# OHIO DEPARTMENT OF TRANSPORTATION

To: Users of the Standard Bridge Drawings  
From: Tim Keller, Administrator, Office of Structural Engineering  
By: Sean Meddles, Bridge Standards Engineer  
Re: Standard Bridge Drawing Updates

TST-1-99:

**SECTION F-F**

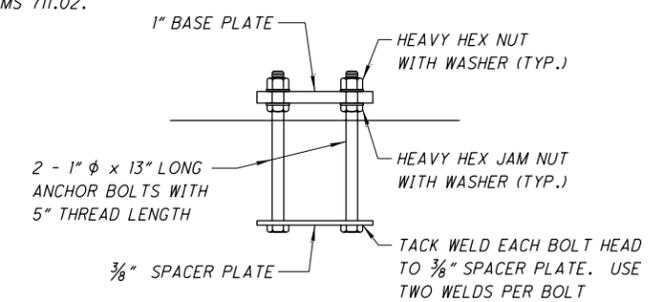
On sheet 1 of 4, Section F-F, a construction joint has been introduced in the abutment wingwall that will allow the bridge railing to be placed as necessary to allow fit-up. After the railing system, including flush mounted posts, is completely erected, the wingwall concrete can be placed above the construction joint to anchor the flush-mounted posts which are temporarily supported from above by the tube rails. In lieu of this construction joint, the drawing provides the Contractor the option to field drill the holes in the tube rails for the tube rail-to-post connections and repair the galvanized coating.

Also on sheet 1 of 4, Section F-F, the non-shrink grout beneath the flush mounted post base plate has been eliminated. The grout adds very little value and prevents visual inspection of the anchors beneath the base plate.

- \*\*\* - PLACE THE CONCRETE ABOVE THE CONSTRUCTION JOINT AFTER INSTALLATION OF THE RAILING IS COMPLETE.
- \*\*\*\* - IN LIEU OF PROVIDING THE WINGWALL CONSTRUCTION JOINT, THE CONTRACTOR MAY FIELD DRILL HOLES IN THE TUBING FOR POST-TO-TUBE RAIL CONNECTIONS AT ALL FLUSH MOUNTED POST LOCATIONS. REPAIR GALVANIZING ACCORDING TO C&MS 711.02.

**SECTION A-A**

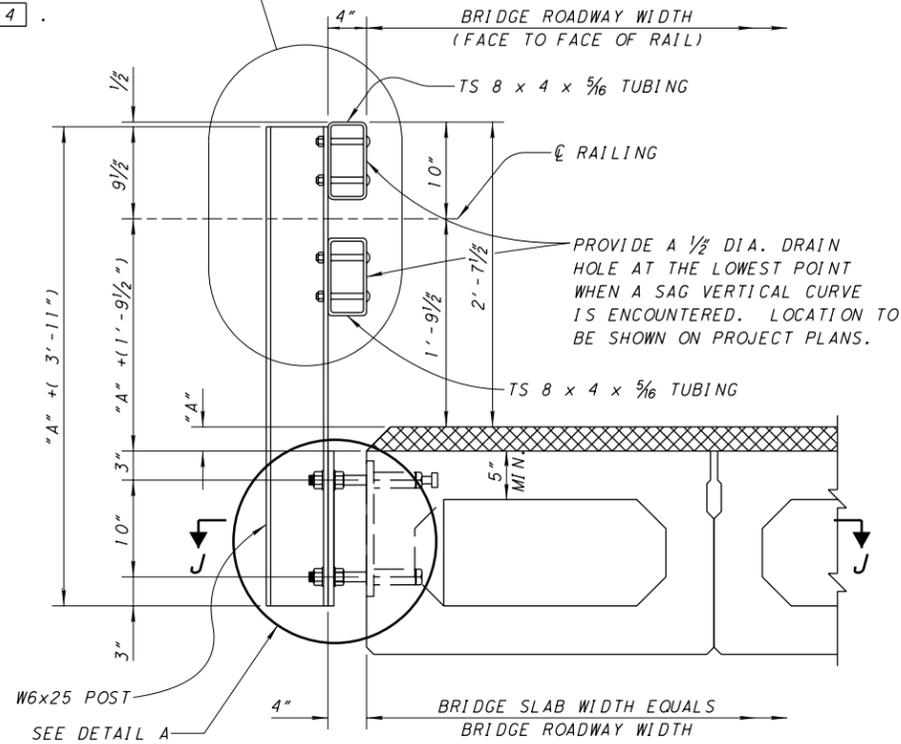
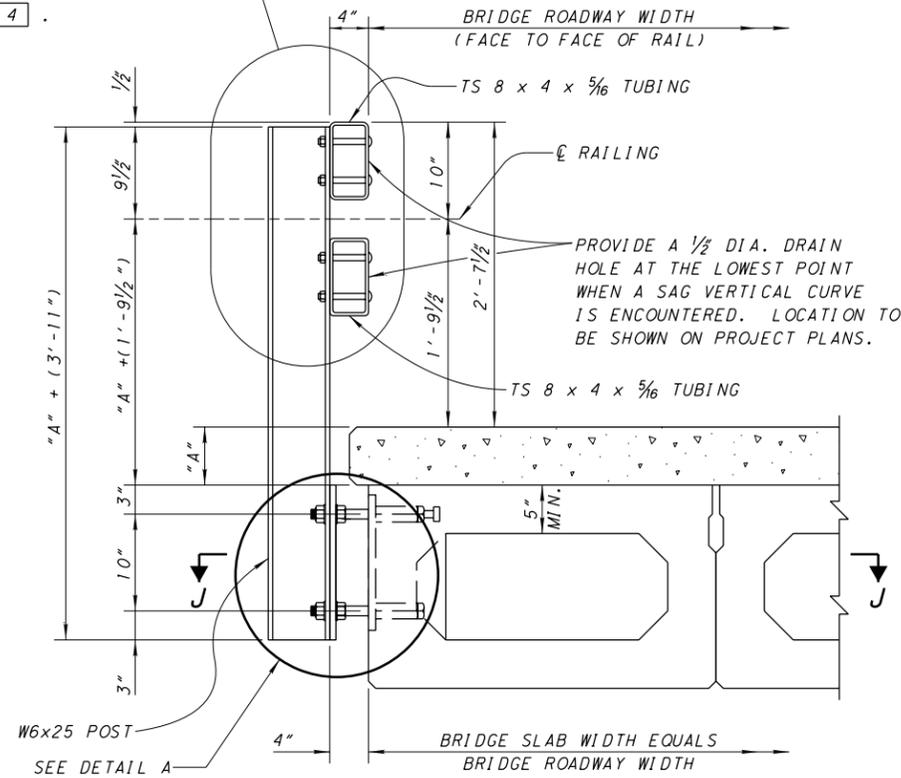
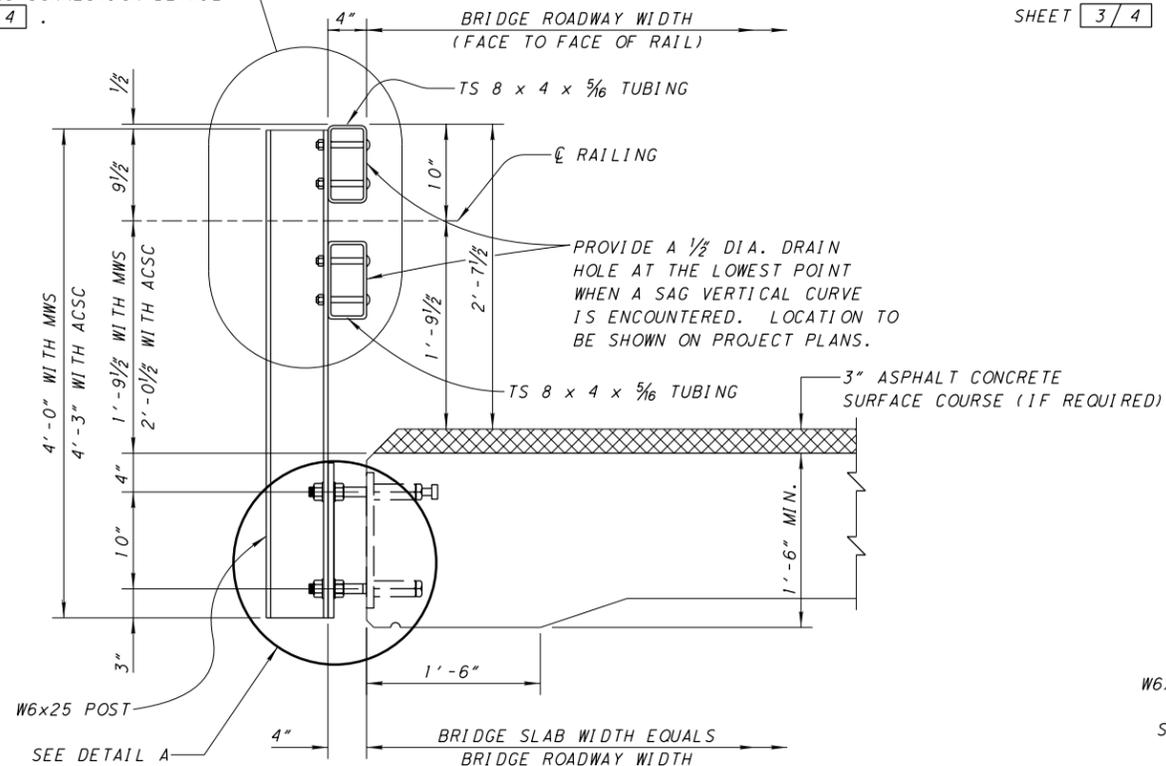
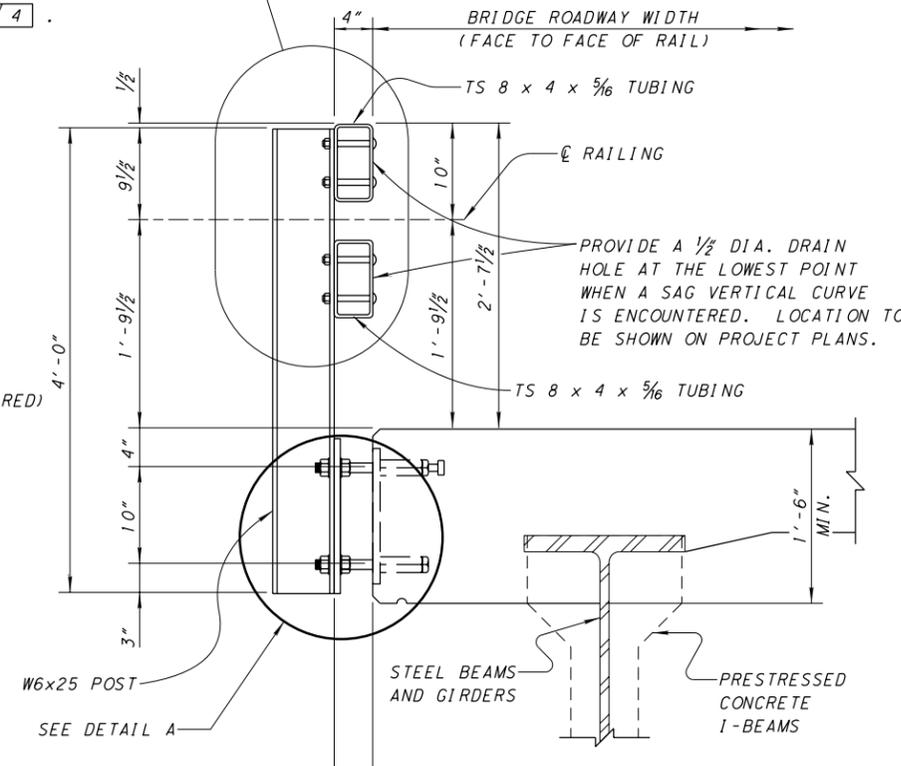
On sheet 2 of 4, Section A-A, Detail A and Section J-J, the 6x3x0.25 steel tubing and 3/8" shim plate have been removed. Our office found numerous existing installations where the shim plates were not drawn tight against the superstructure fascia. When installed in this position, the tubing and shim do not provide the compressive support intended thus requiring the lower anchor bolts carry the entire compressive load to the superstructure. The 1" diameter anchor bolts have sufficient capacity without the additional compression support provided by the tubing and shim plate.
